SPRINGS AT WATERVIEW  
DRAINAGE LETTER  
EL PASO COUNTY, COLORADO

February 2020

PCD No. SP-16-005  
PCD No. SF-16-017

The ponding elevation of 72-inch RCP.

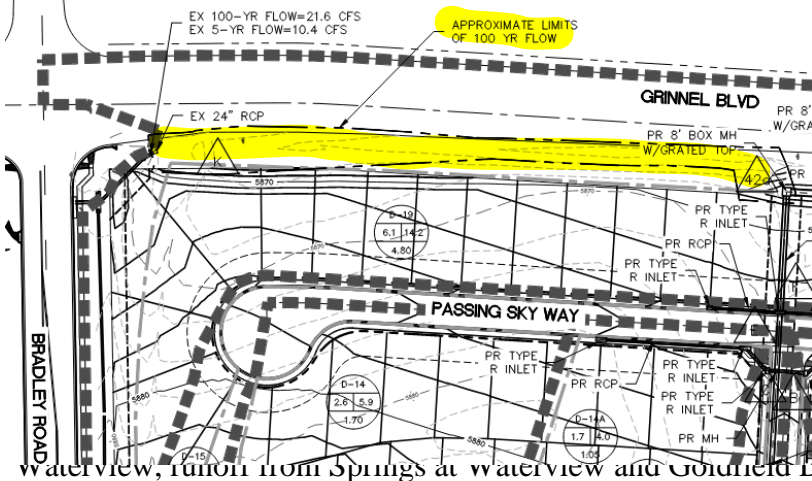
The approved FDR's analysis showed the 100yr flow stays within the shoulder with no overtopping of Grinnell Blvd.

**Figure 5: Proposed Drainage Map**

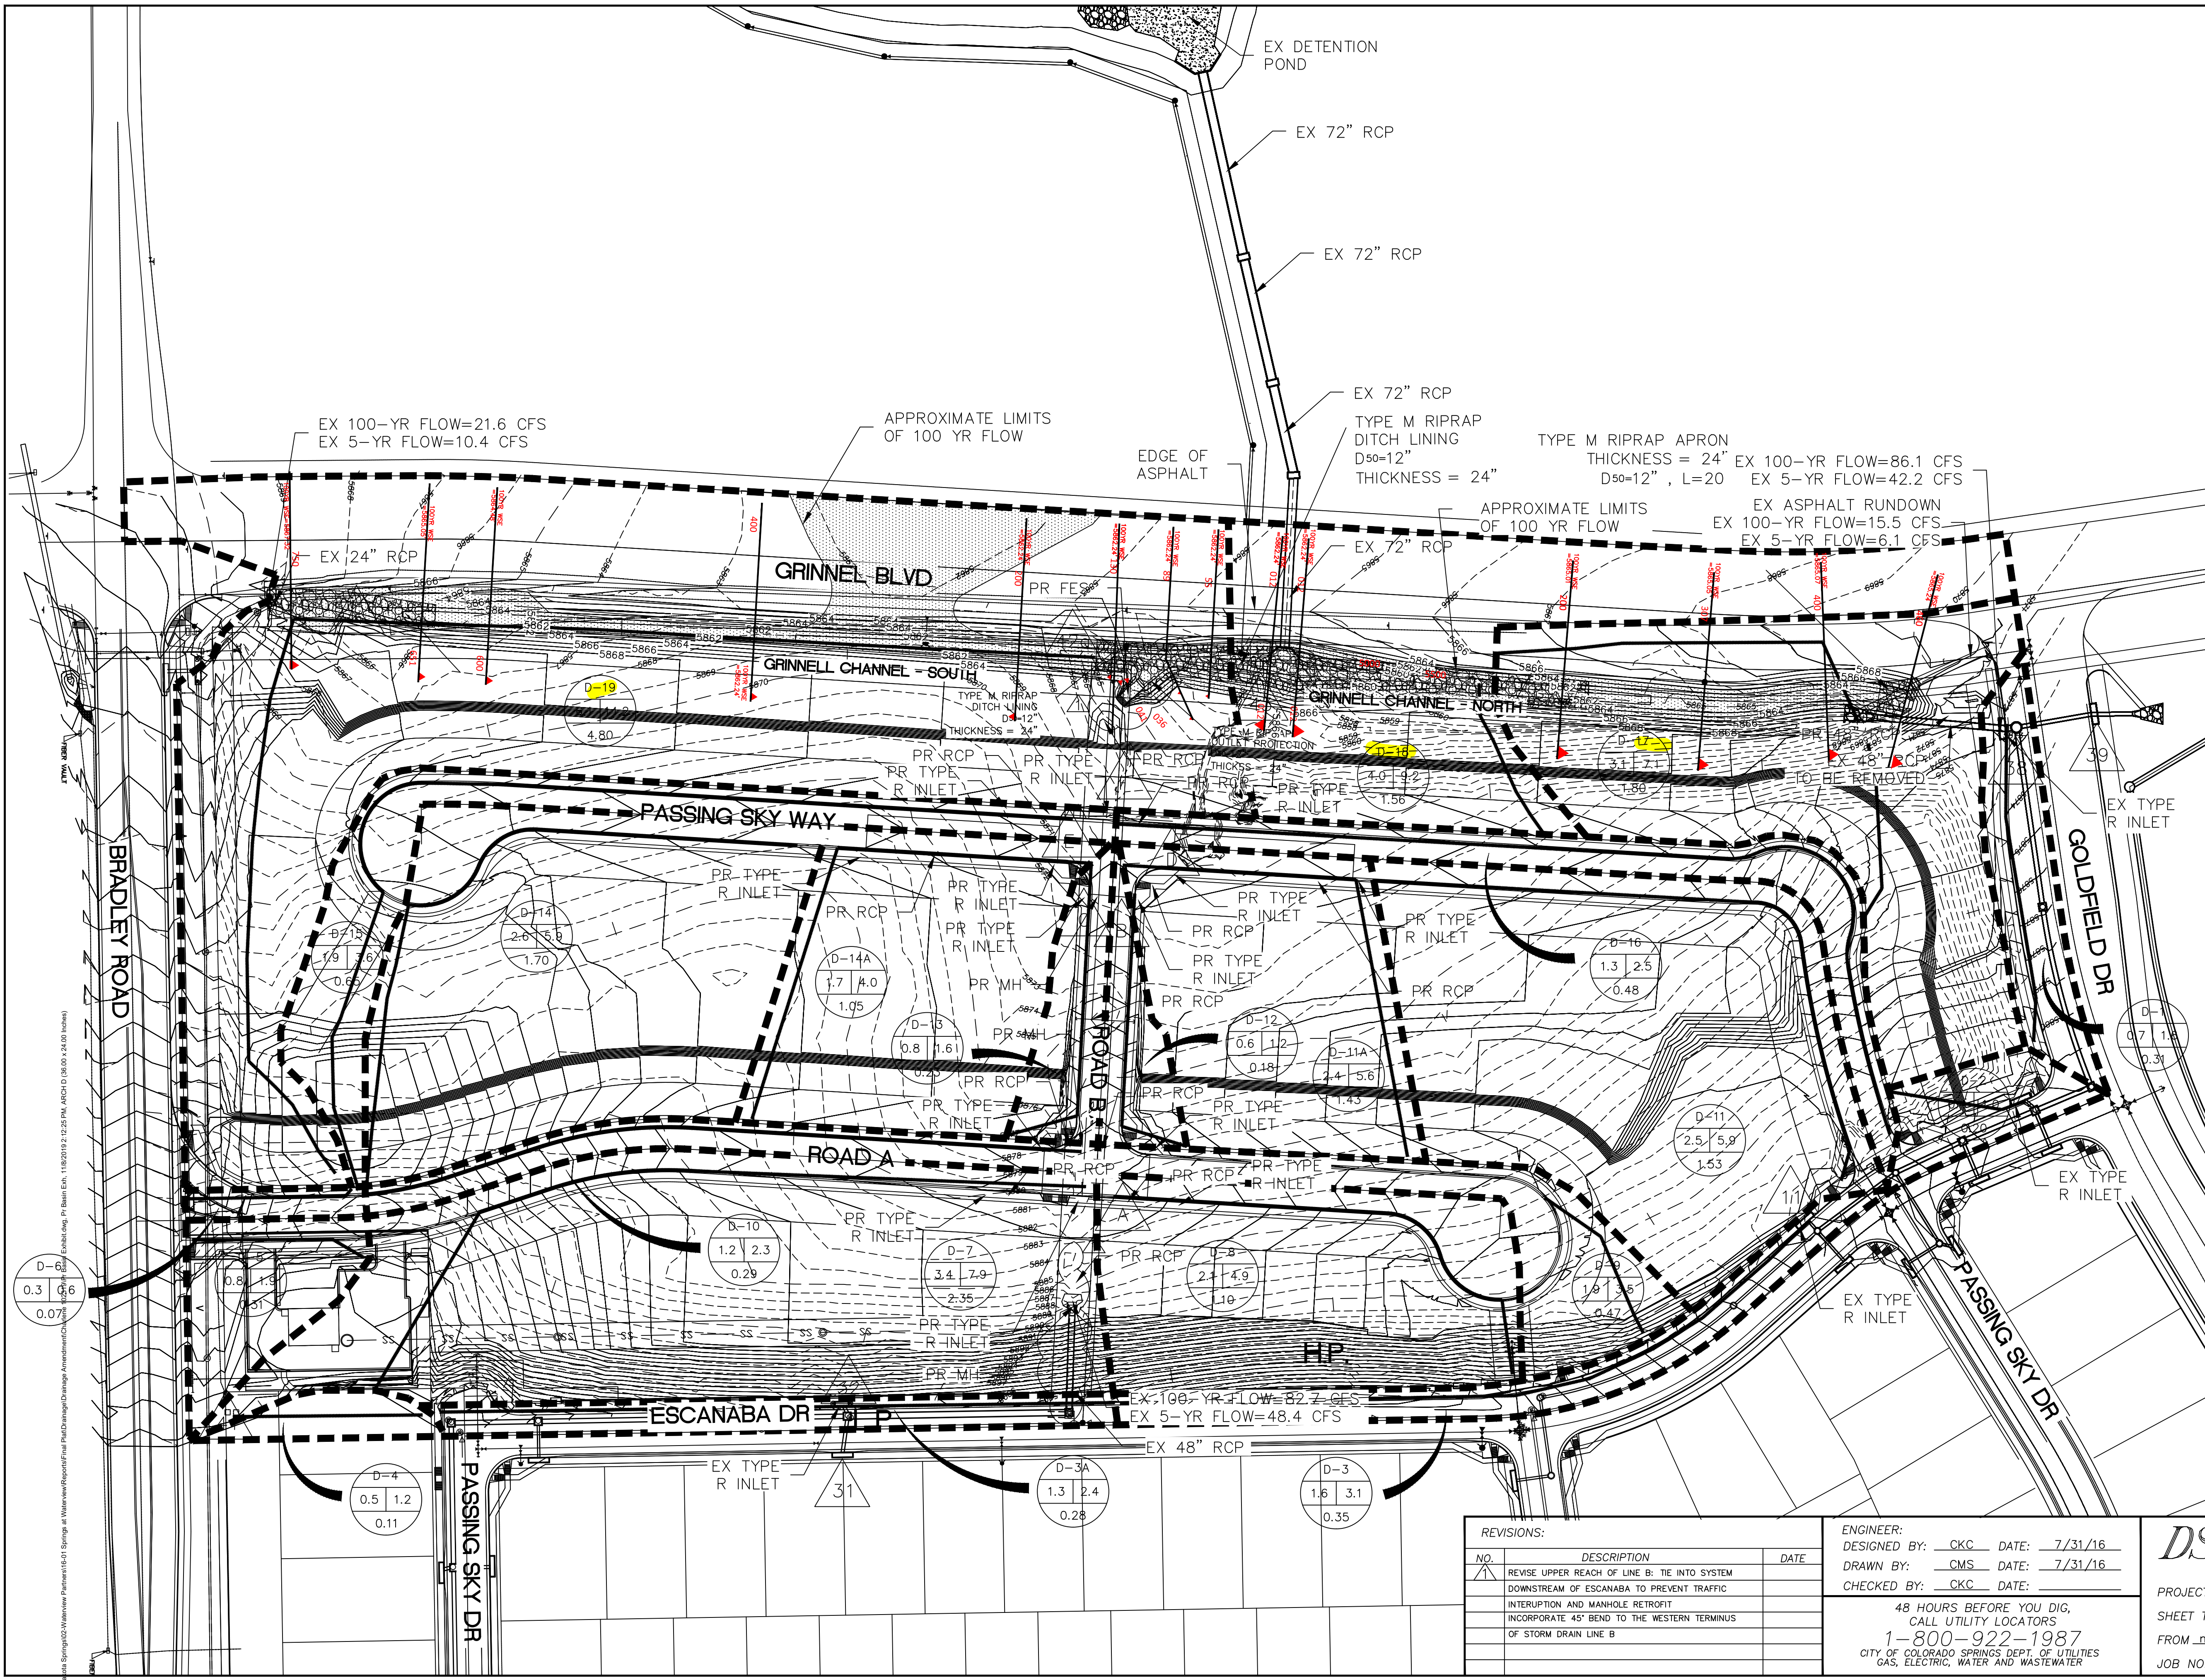
These values are based on subbasin Q's, not cumulative. Include columns for the cumulative flows used in the HEC-RAS Modeling.

HEC-RAS Plan: Plan 04

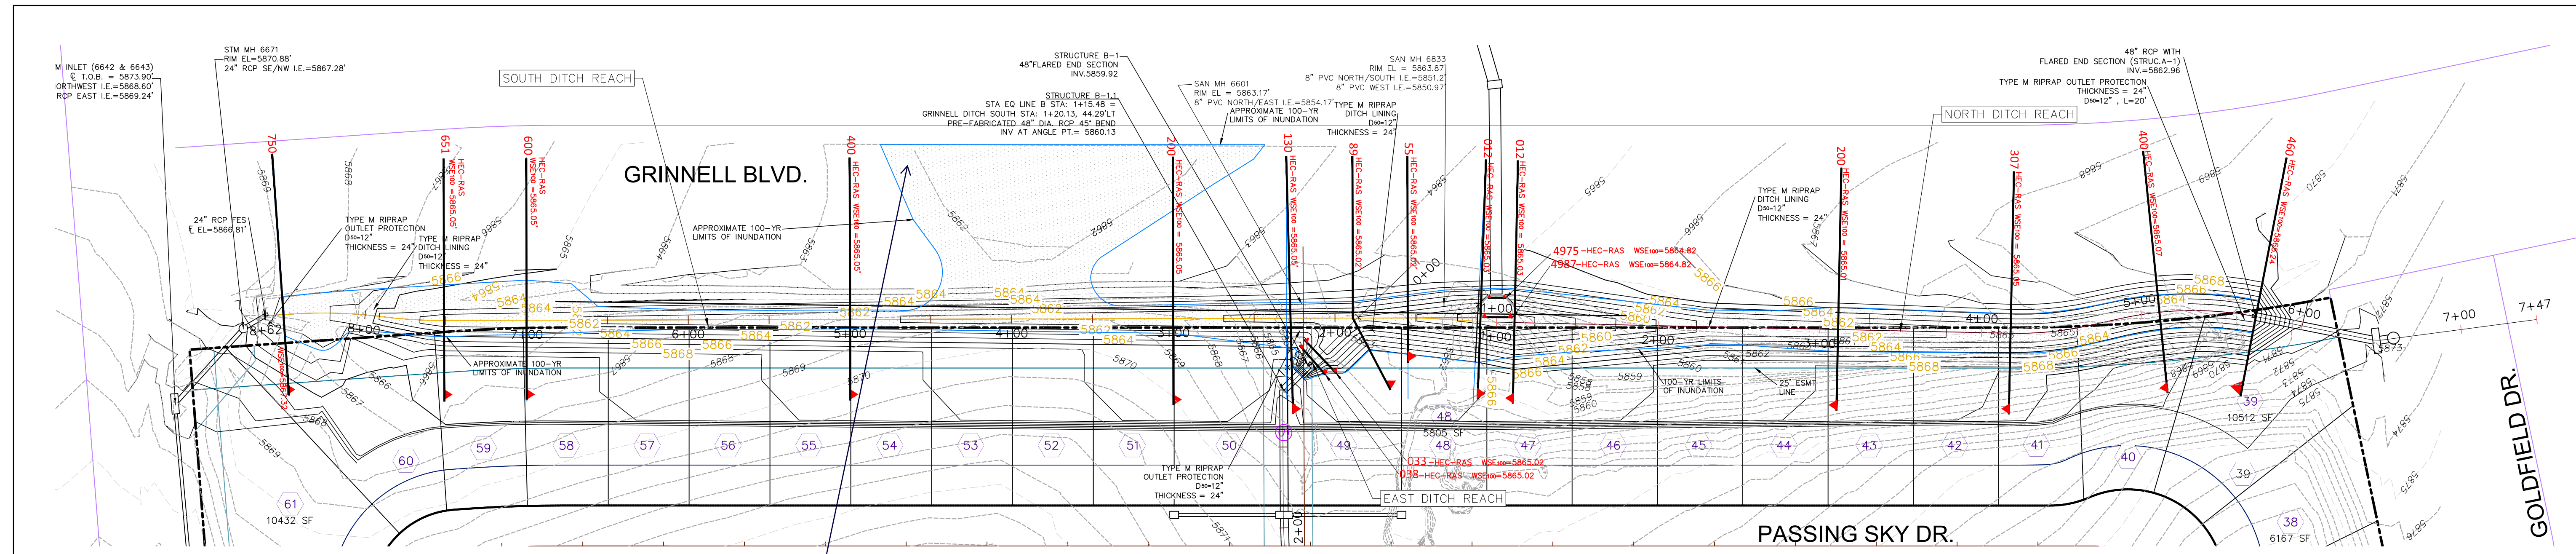
Update the narrative to identify the design storm associated with PF 1 and PF 2 or update the profile names to their respective storm events.

### NORTH & SOUTH REACHES

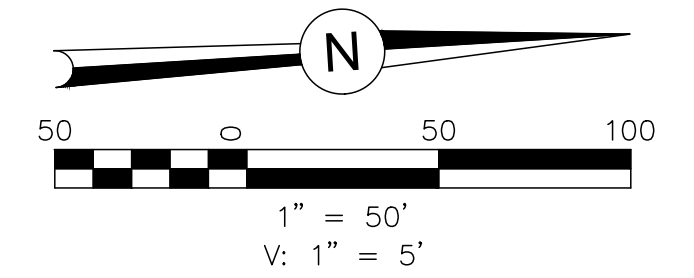
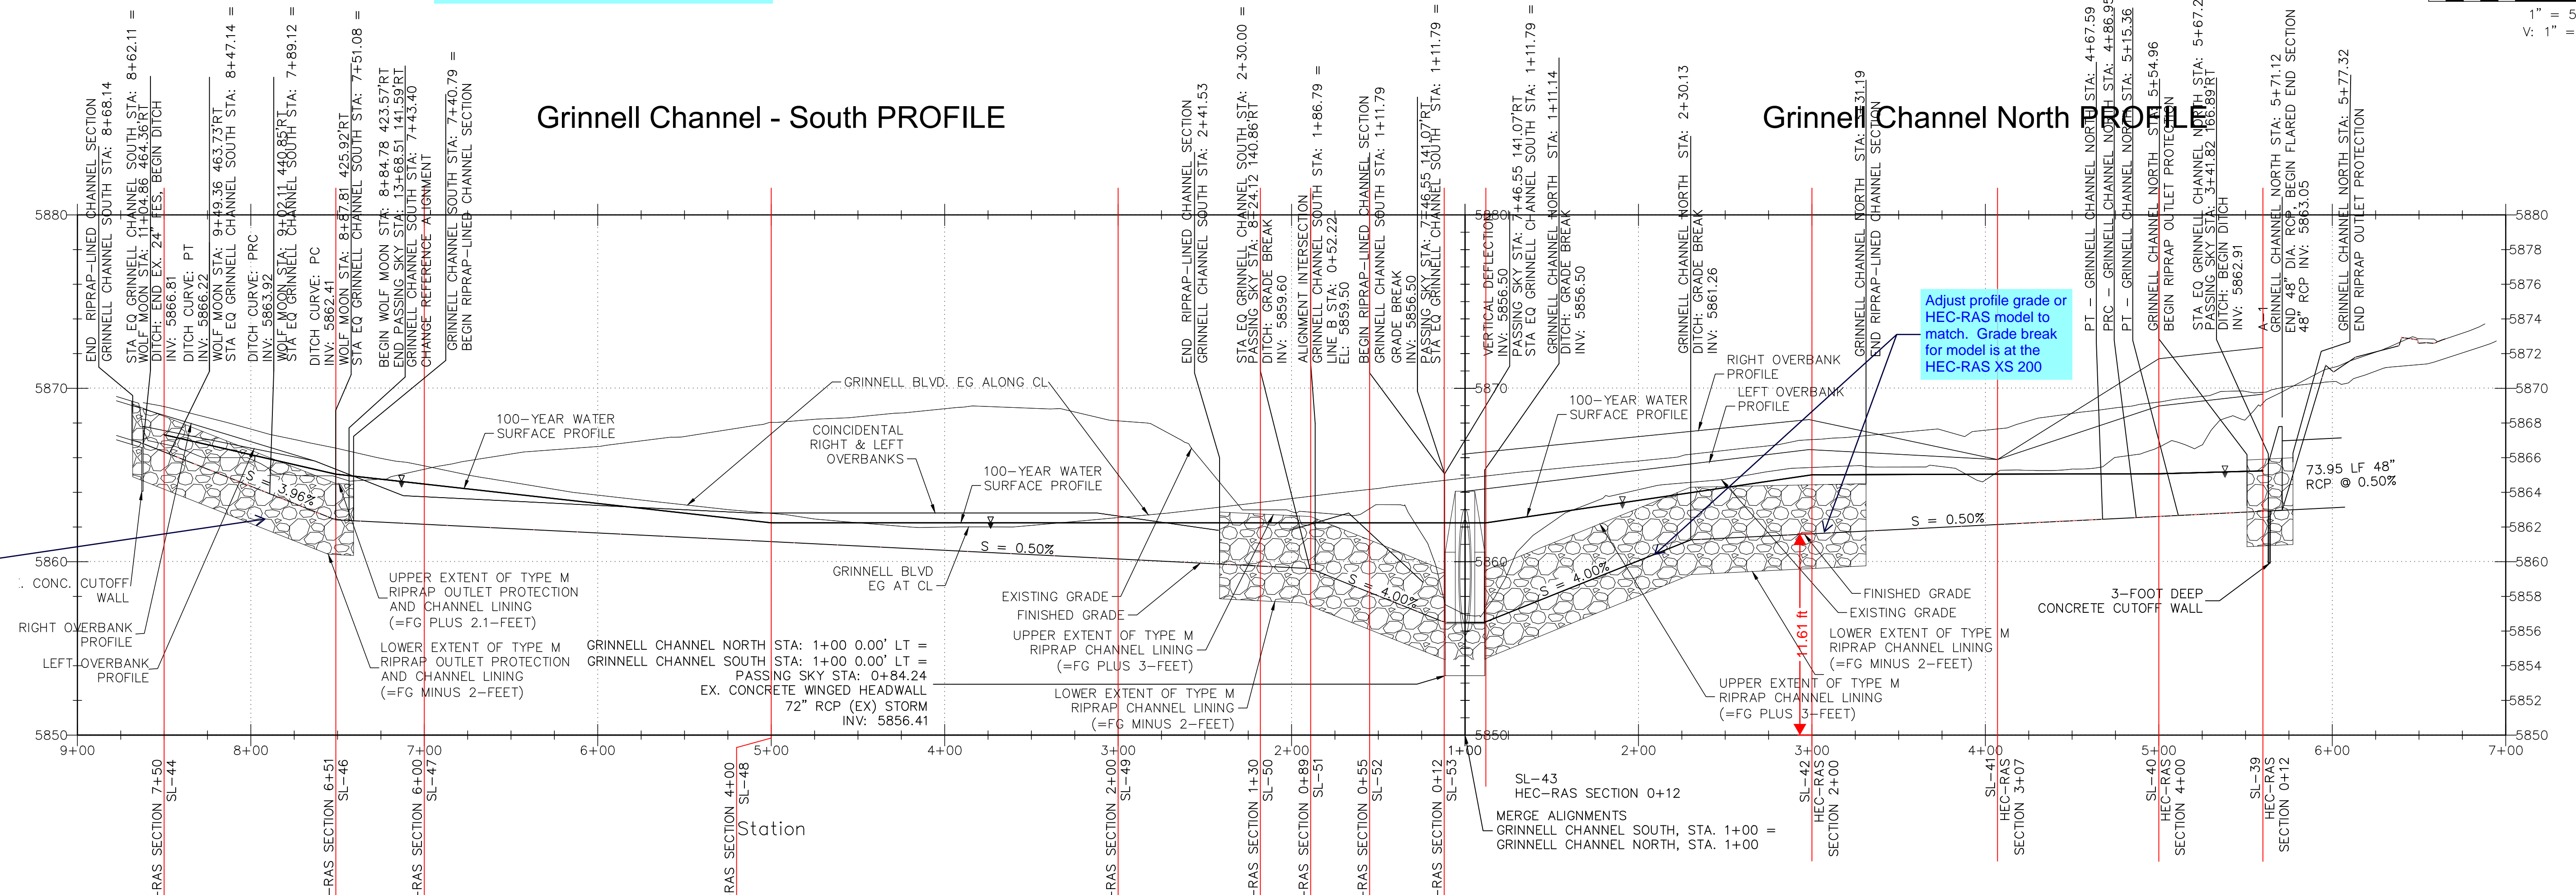
Revise ditch design to meet criteria. Per DCM Table 6-1 flow must not encroach upon road shoulder area.

Add the riprap sizing calculations.

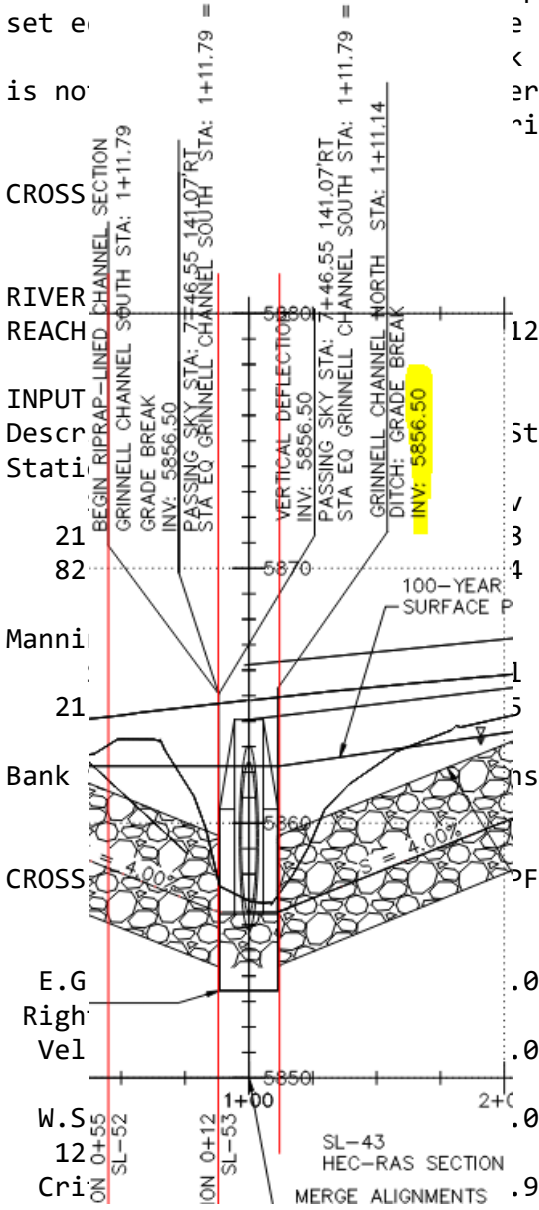
Bottom of channel cross section does not match the plans. Update.

**Table 2 - Culvert Summary Table: ex.72**

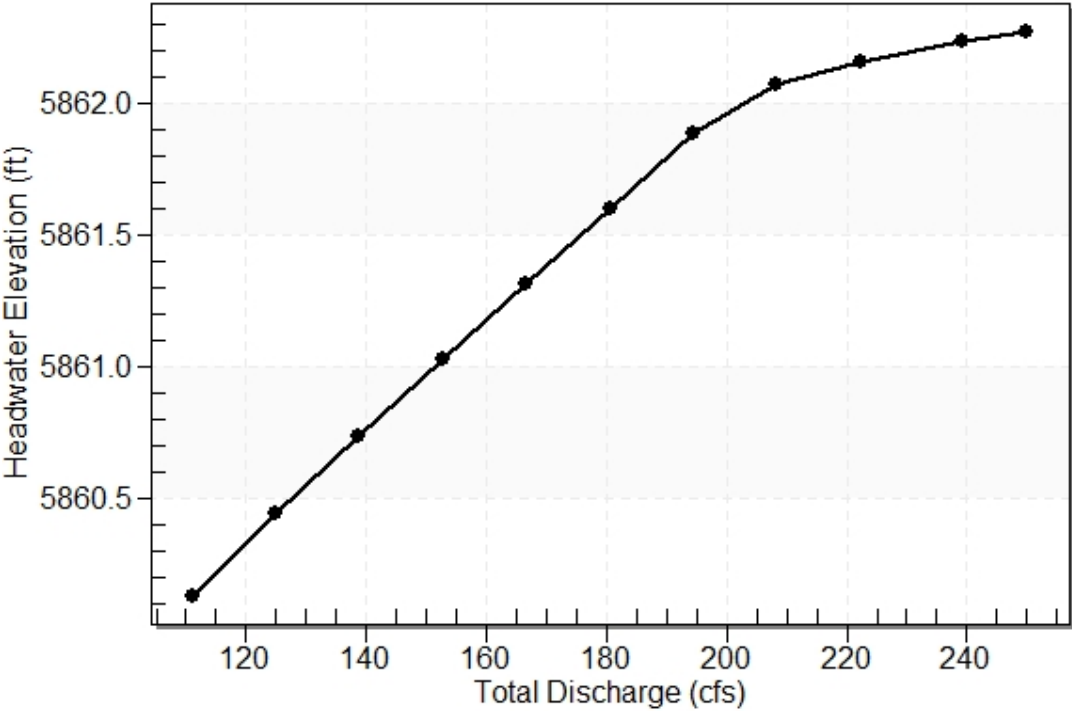
Does not meet criteria for overtopping. Revise design.
